**BEFORE
THE OHIO POWER SITING BOARD**

In the Matter of the Application of)	
Kingwood Solar I LLC for a Certificate)	Case No. 21-0117-EL-BGN
of Environmental Compatibility and)	
Public Need)

**KINGWOOD SOLAR'S JUNE 1, 2021 RESPONSES
TO STAFF'S MAY 17 AND MAY 20 DATA REQUESTS**

Figure 08-11
Land Use within One Mile
Sheet 13 of 29
Kingwood Solar
Greene County, Ohio

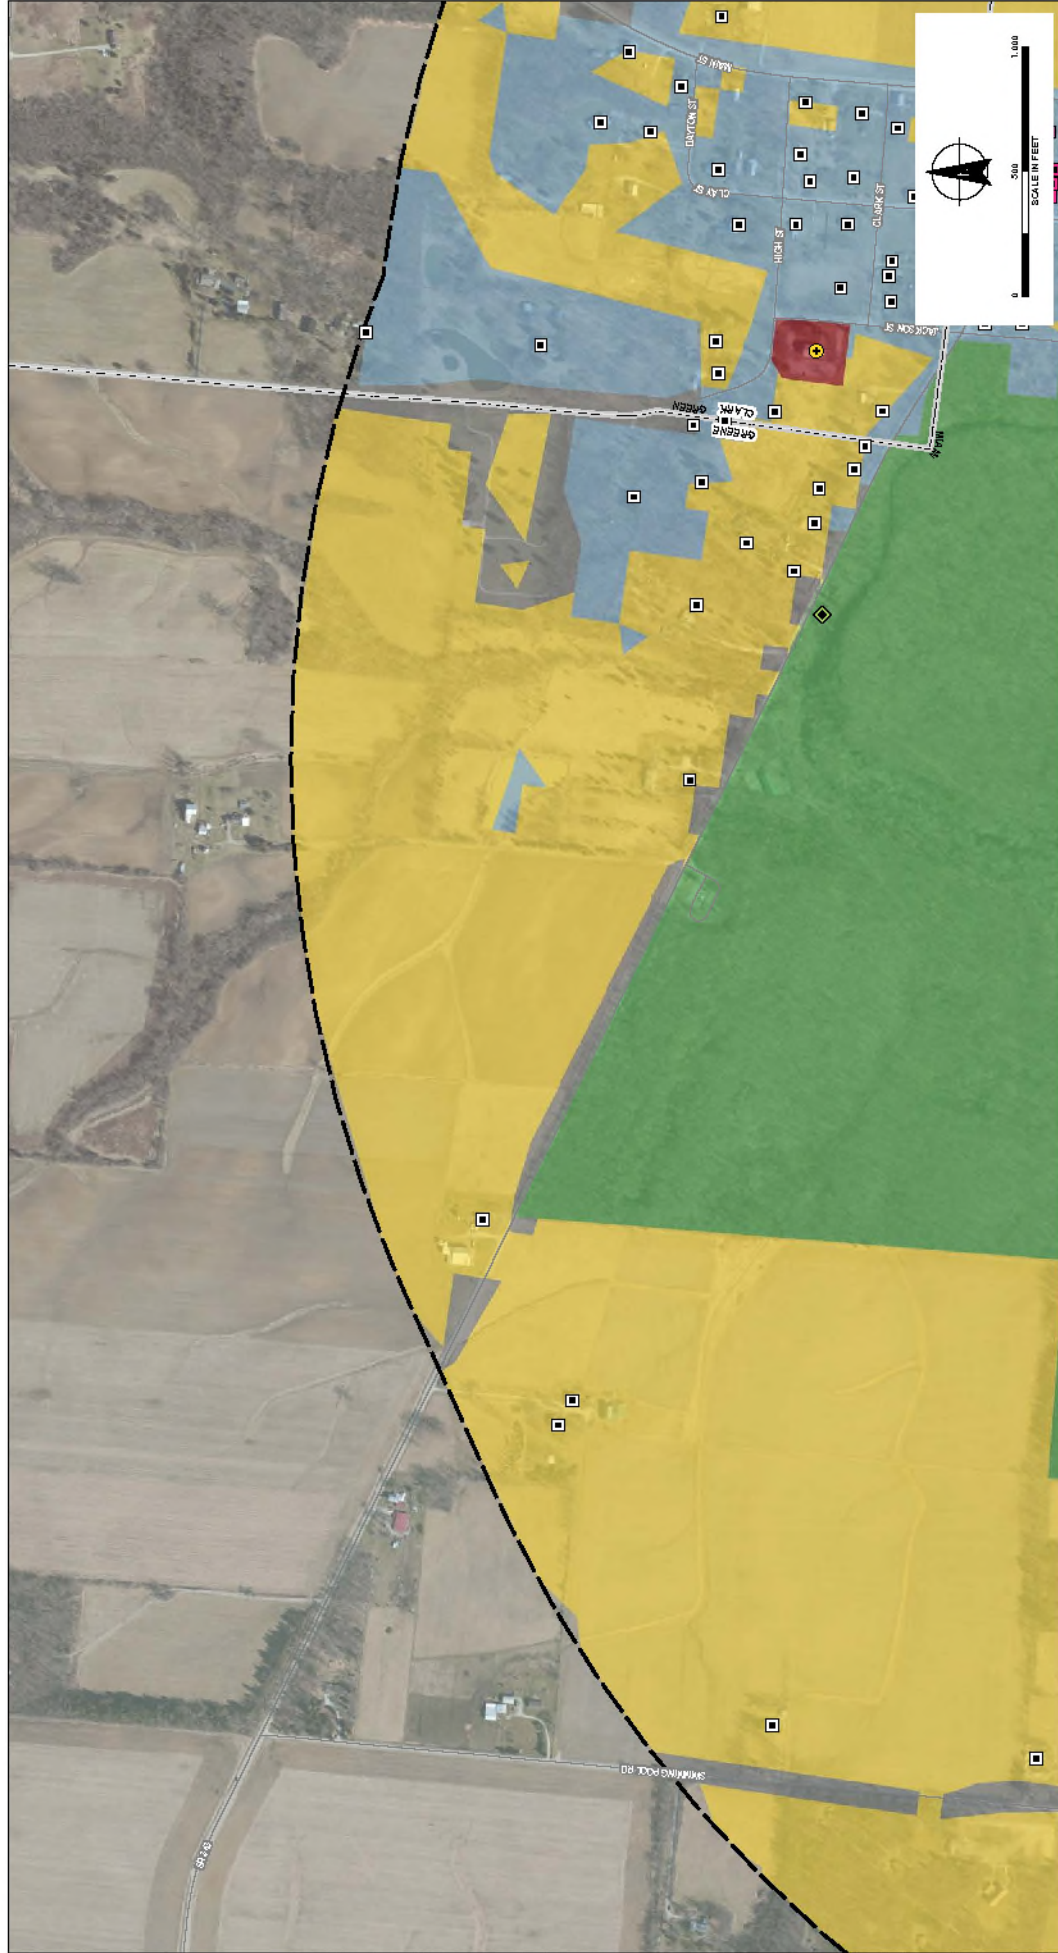
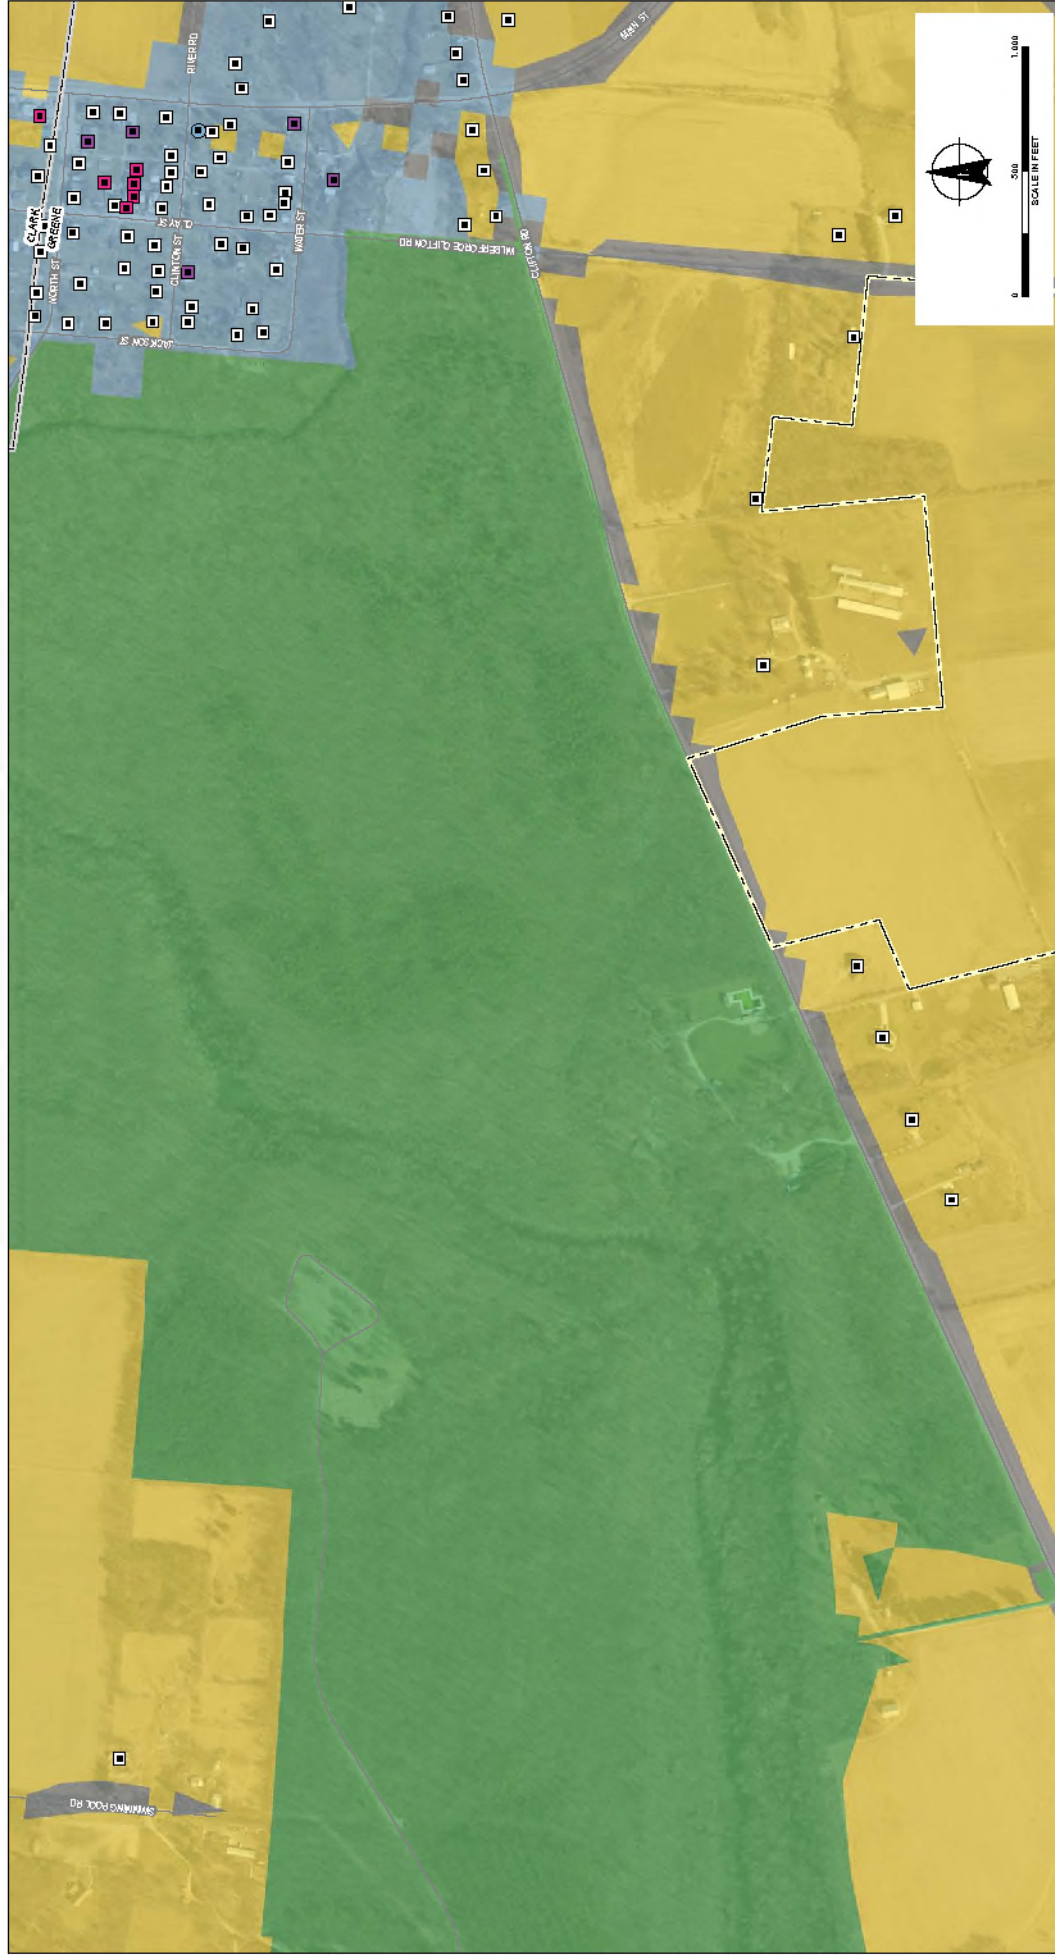
1. *Figure 8-11 currently only delineates schools and residences. Amend Figure 8-11 to include the following structures depicted as points on the map, as per 4906-4-08(C)(1)(a): "...commercial centers or buildings, industrial buildings and installations,...hospitals, churches, civic buildings, and other occupied places".*

A revised version of Figure 08-11 is attached that provides points on the maps for the requested features.
